Subject: Inspection of CONESTEE LAKE DAM, D2876, Greenville County, Significant Hazard Class

Enclosure: CONESTEE LAKE DAM (D2876) Preliminary Inspection

Dams Preliminary Inspection Form

Concrete/Masonry Dams: Upstream Face

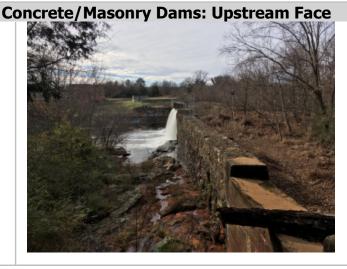
Could not be inspected due to the build up of sediment behind the dam and the primary spillway section was submerged.

Could not be inspected due to the build up of sediment behind the dam and the primary spillway section was submerged.

Could not be inspected due to the build up of sediment behind the dam and the primary spillway section was submerged.

Could not be inspected due to the build up of sediment behind the dam and the primary spillway section was submerged.
